**CITY OF TEMPE
DEVELOPMENT REVIEW COMMISSION**

**Meeting Date: 08/12/2014
Agenda Item: 2**

ACTION: Request for a Development Plan Review consisting of a new 2,961 s.f. restaurant with drive-through for POPEYE’S LOUISIANA KITCHEN, located at 1615 West Elliot Road. The applicant is SBL Engineering LLC.

DPR14117 Development Plan Review including site plan, building elevations, and landscape plan.

sheet no.
 L-1

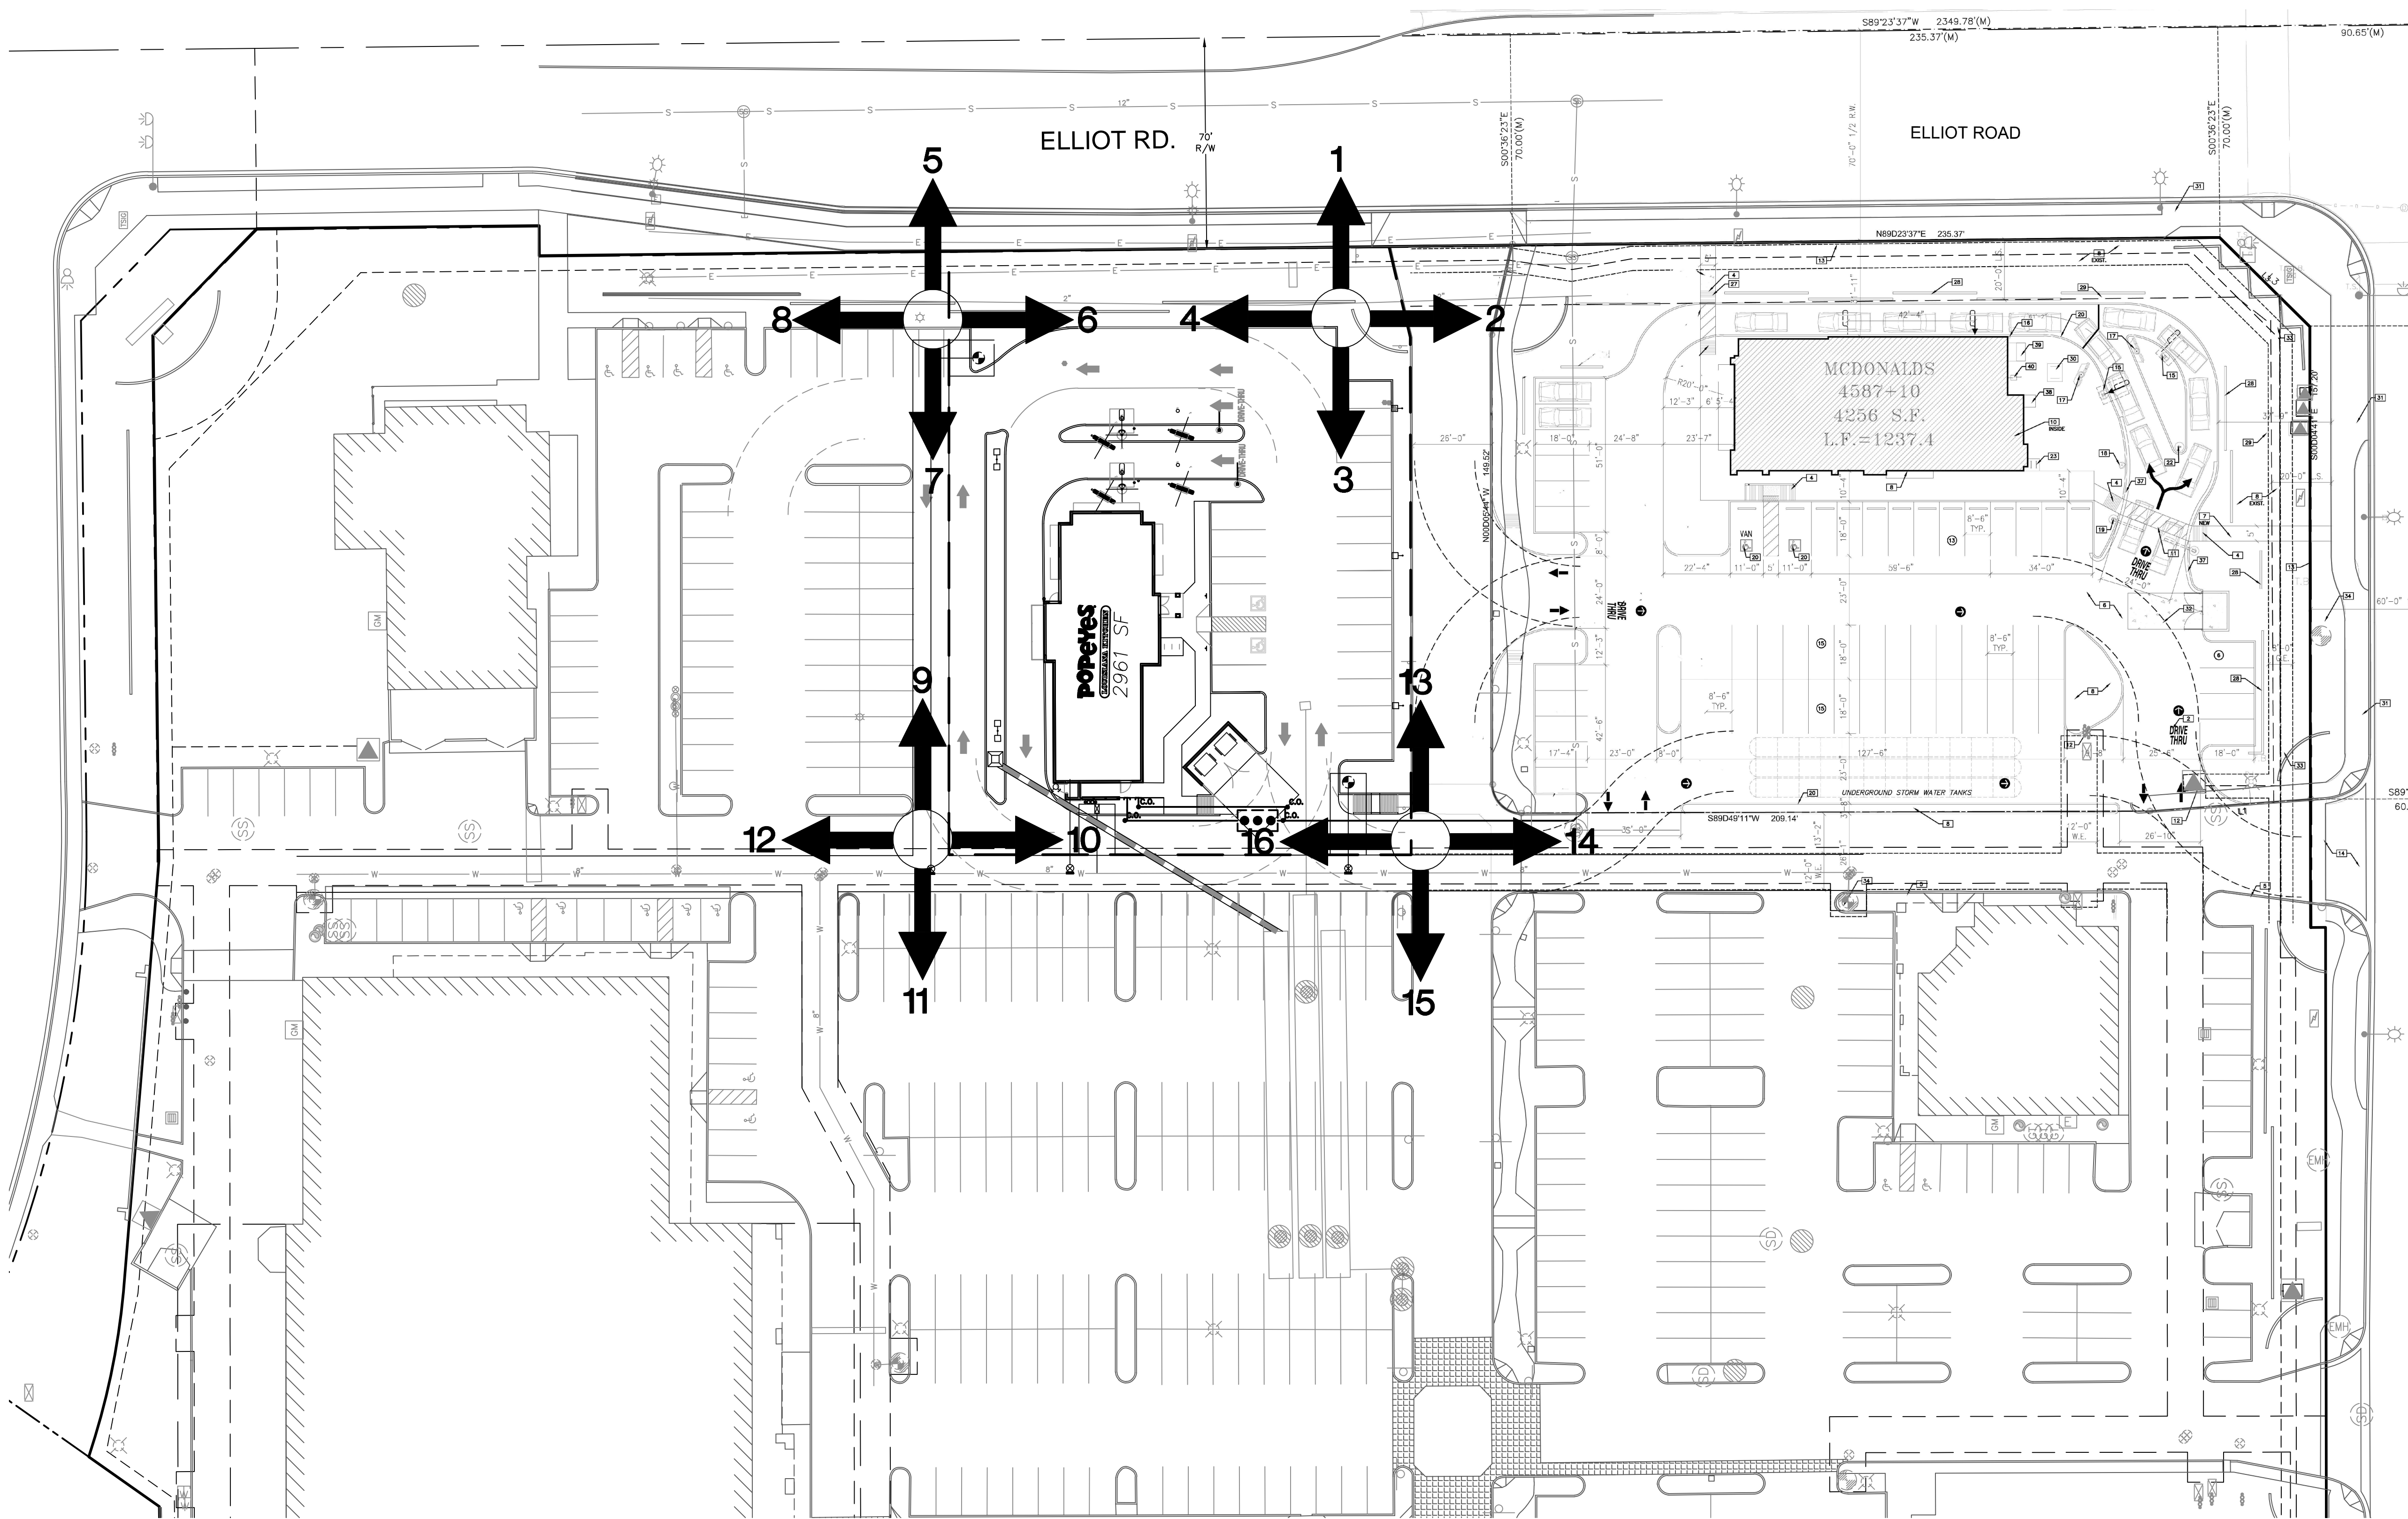
12. Irrigation notes:
 - a. Provide pipe distribution system of buried rigid (polyvinylchloride), not flexible (polyethylene). Use of schedule 40 PVC mainline and class 315 PVC ½" feeder line is acceptable. Class 200 PVC feeder line may be used for sizes greater than ½". Provide details of water distribution system.

13. Include requirement to de-compact soil in planting areas on site and in public right of way and remove construction debris from planting areas prior to landscape installation.

14. Top dress planting areas with a rock or decomposed granite application. Provide rock or decomposed granite of 2" uniform thickness. Provide pre-emergence weed control application and do not underlay rock or decomposed granite application with plastic.

15. Trees shall be planted a minimum of 12'-0" from any existing or proposed public water or sewer lines located on-site. Trees near the main water or sewer lines located within the right of way shall be planted at least 20'-0" away. Final approval subject to determination by the Public Works, Water Utilities Division.
